# AGENDA

**Planning Committee meeting to be held  
at Darebin Civic Centre,  
350 High Street Preston  
on Monday, 8 August 2016  
at 7.00 pm.**

### 5.1 APPLICATION FOR PLANNING PERMIT D/400/2015 60 Burbank Drive, Reservoir

**5.2 APPLICATION FOR PLANNING PERMIT D/934/2015**

04

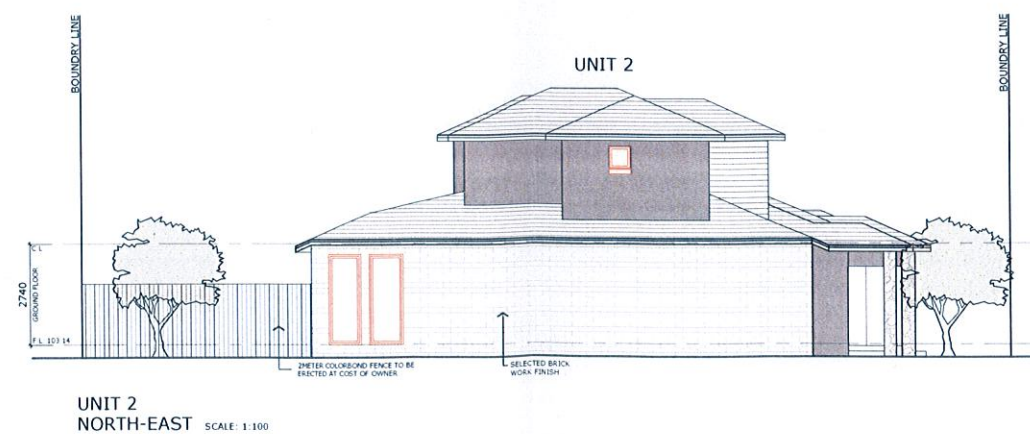
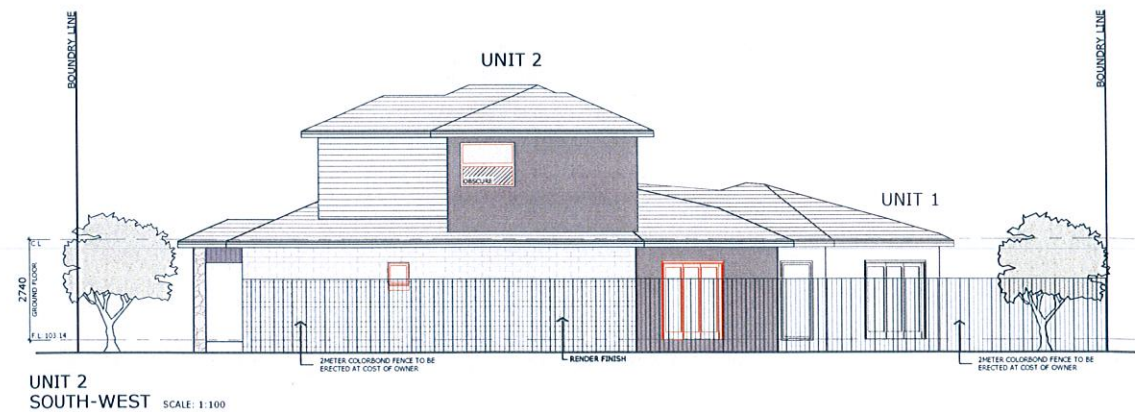
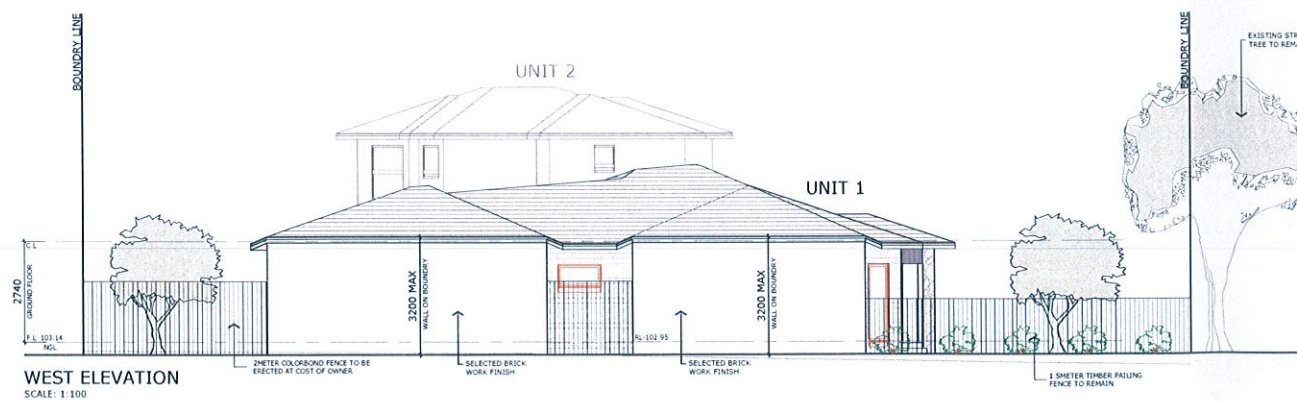
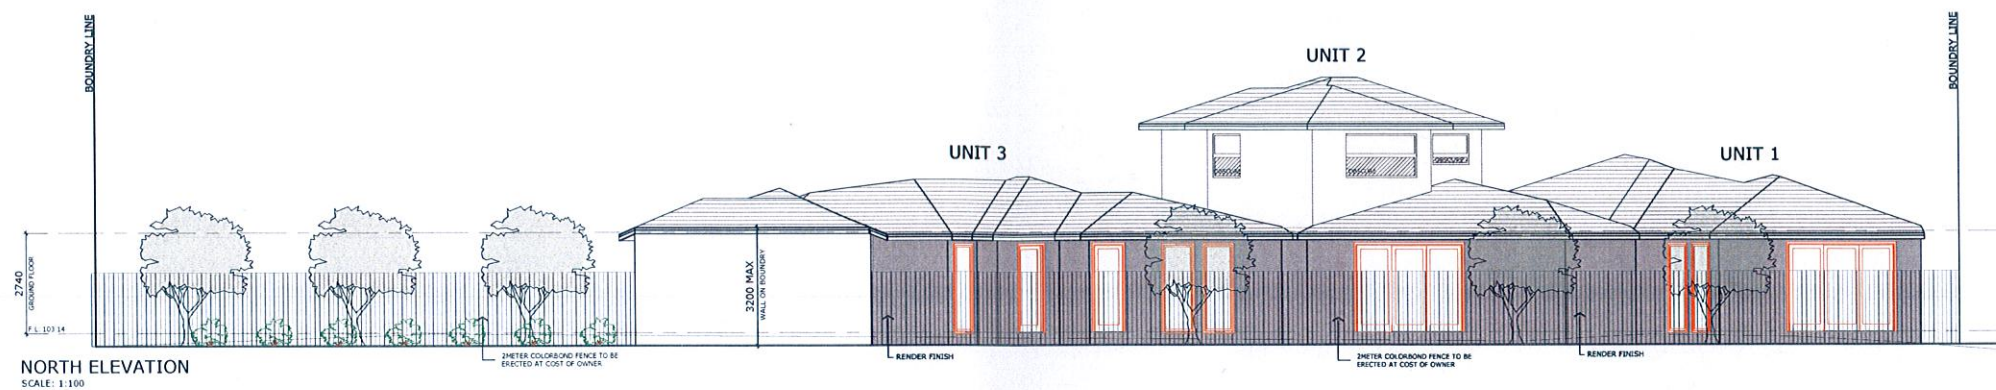
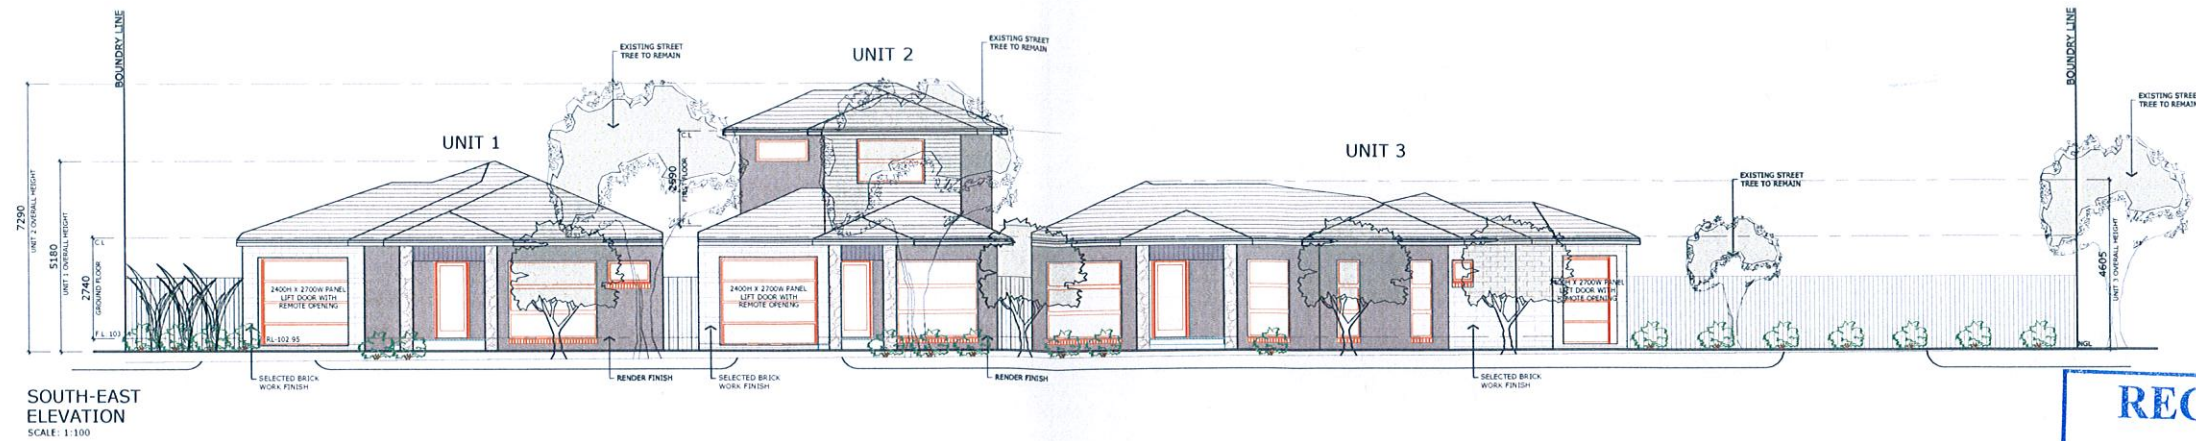
- a) Drawing Sheet 04 dated 29 March 2016 named correctly as First Floor Plan.
  - b) All finished floor levels including the garages, ground floor and first floor levels nominated on the plans and shown to Australian Height Datum (AHD).

Shadow Diagram: 1:200 9am  
March 21 - September 23 (Equinox)  
Standard Time  
Melbourne (Latitude 38.0° South)

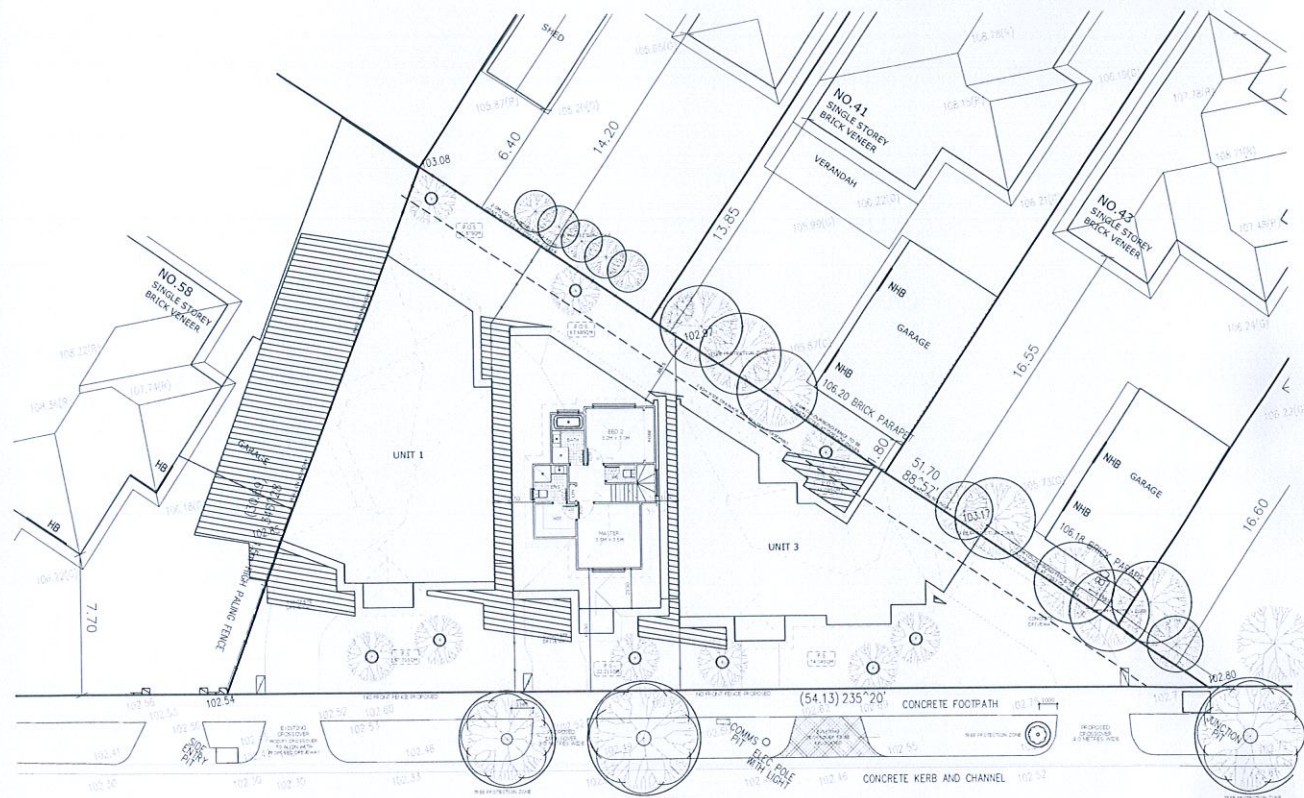
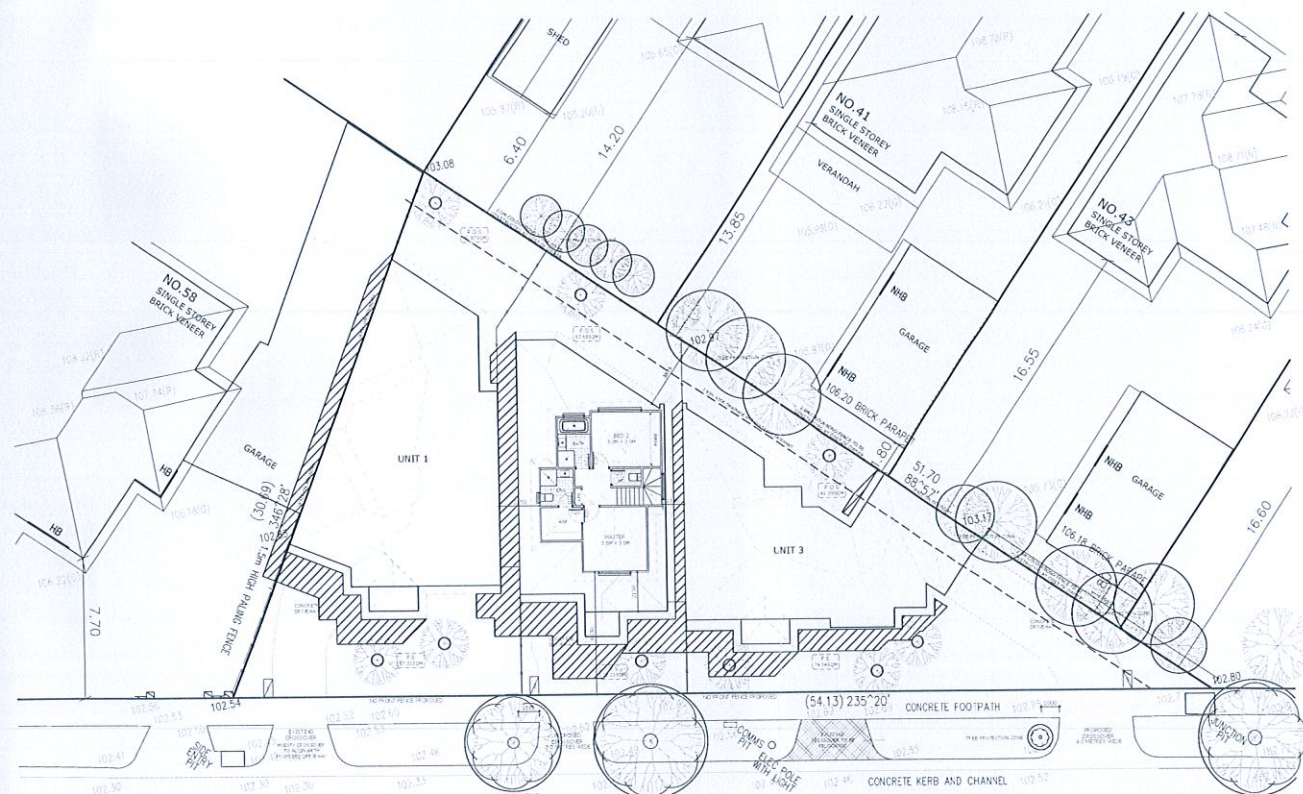
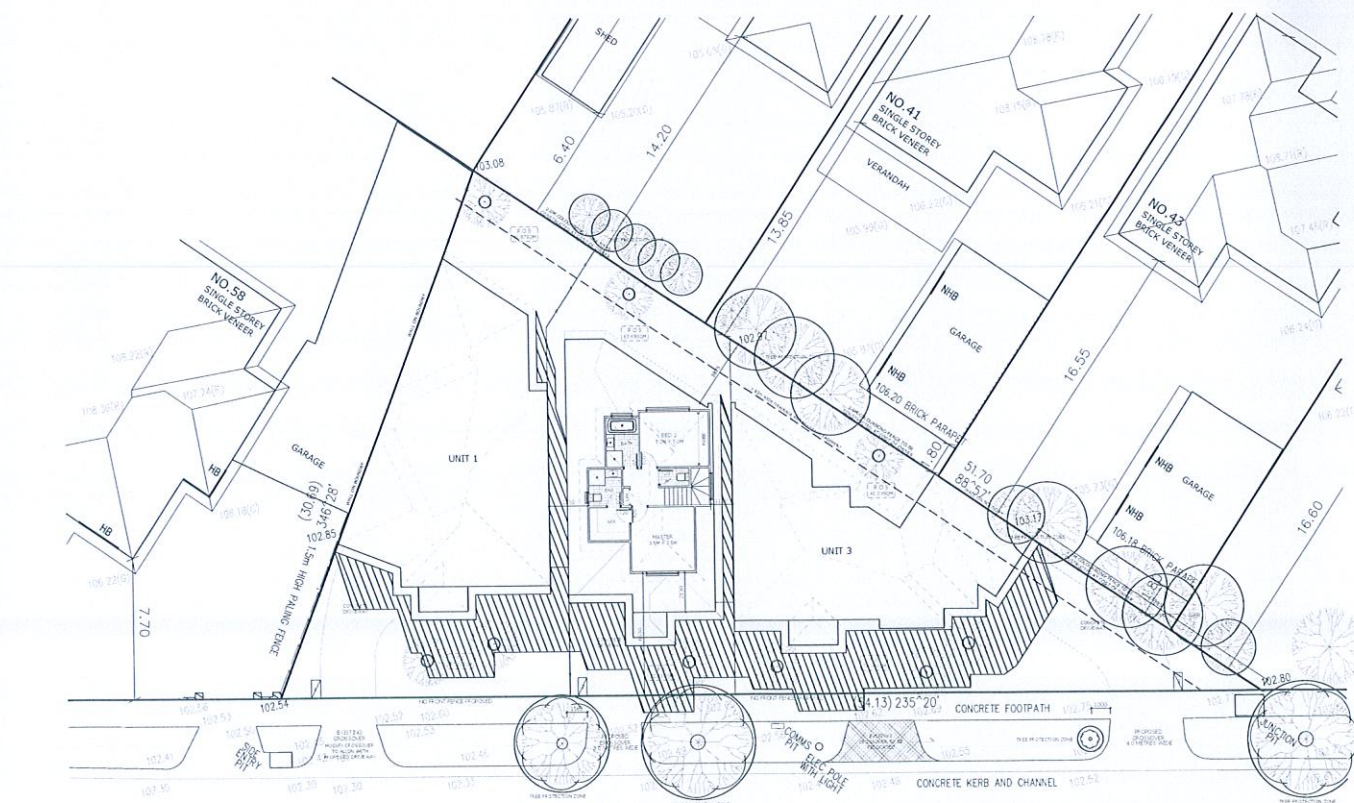
The overshadowing diagrams have been updated to reflect the amended proposal which will have significantly less overshadowing effects given the two (2) dwellings which have a common boundary interface to the east and west have been revised from double-storey to single-storey height, resulting in less amenity impacts on the respective adjoining sites.
